Nevada Division of
WATER RESOURCES

Re: Grand Park Detention Basin (NV10952, J-766) Engineering Design Change (EDC) Approval

**Re: Geotechnical Letter
Grand Park Detention Basin
Summerlin Village 25
Las Vegas, Nevada
Nova Project No.: G-18-232**

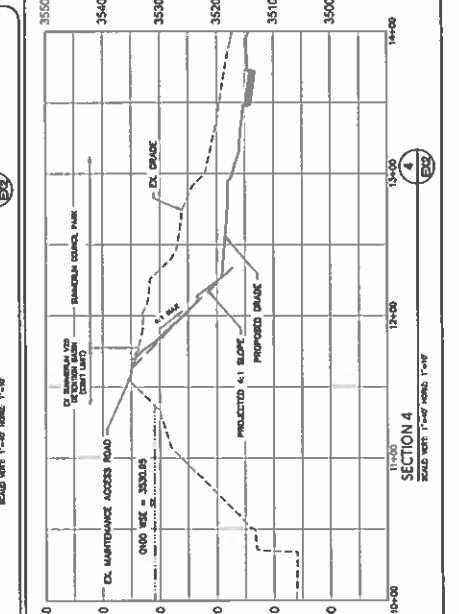
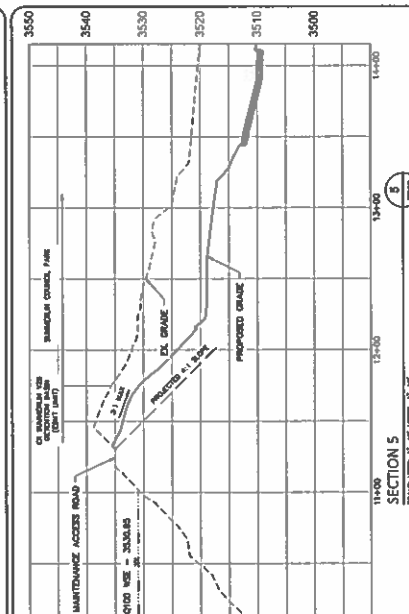
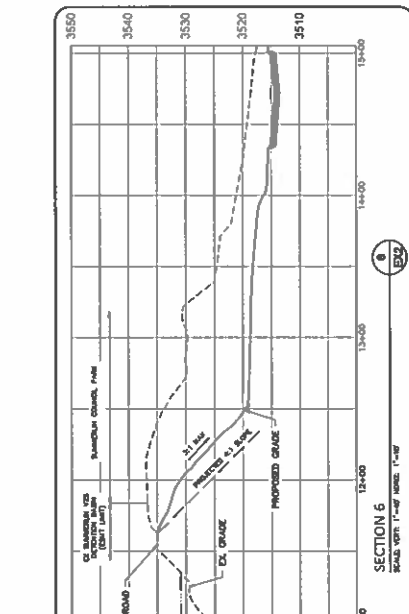
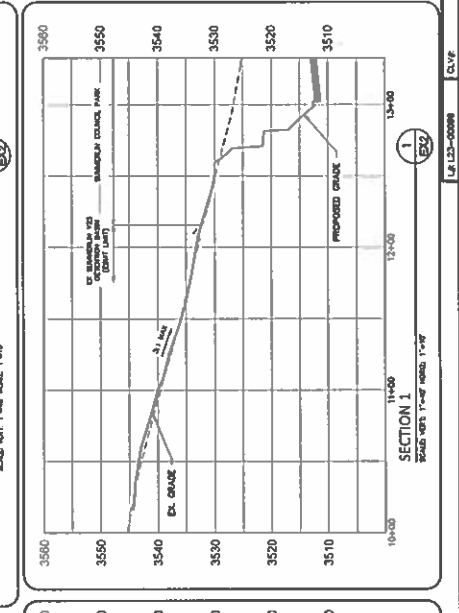
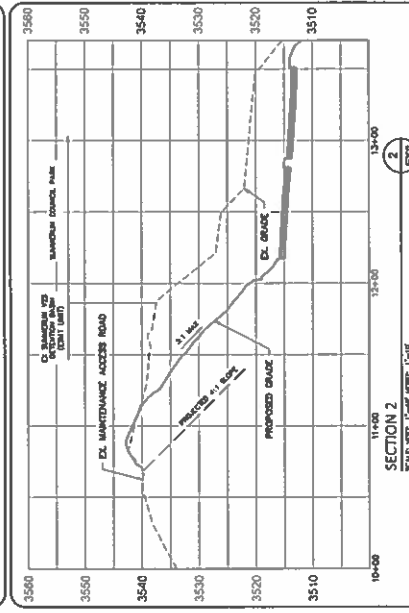
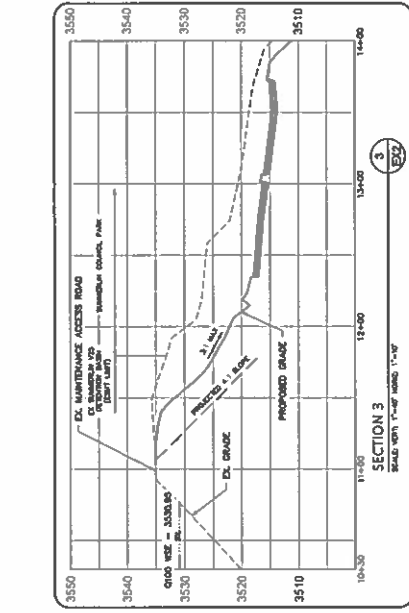
On May 10, 2023, our office received an EDC request for the construction of a park downstream of the Grand Park Detention Basin Dam. The EDC is approved as submitted.

Upon completion of the project, please submit an updated 'as-built' survey of the detention basin with the downstream modifications to verify that the project was constructed per the approved EDC. This can be updated as-builts of the three sheets submitted to support the EDC (EX1 through EX3).

Based on our review of cross-section exhibits provided to us by GCW, it appears that the natural impoundment will be cut back on the downstream side. The seepage and slope stability analysis conducted for the basin was based on 4 to 1 (horizontal to vertical) slopes. The cross-sections provided to us show that the proposed slopes are all above a projected 4 to 1 slope. Therefore, it is our opinion that the proposed cuts for Grand Park will not encroach enough on the impoundment to necessitate additional slope stability and seepage analyses.
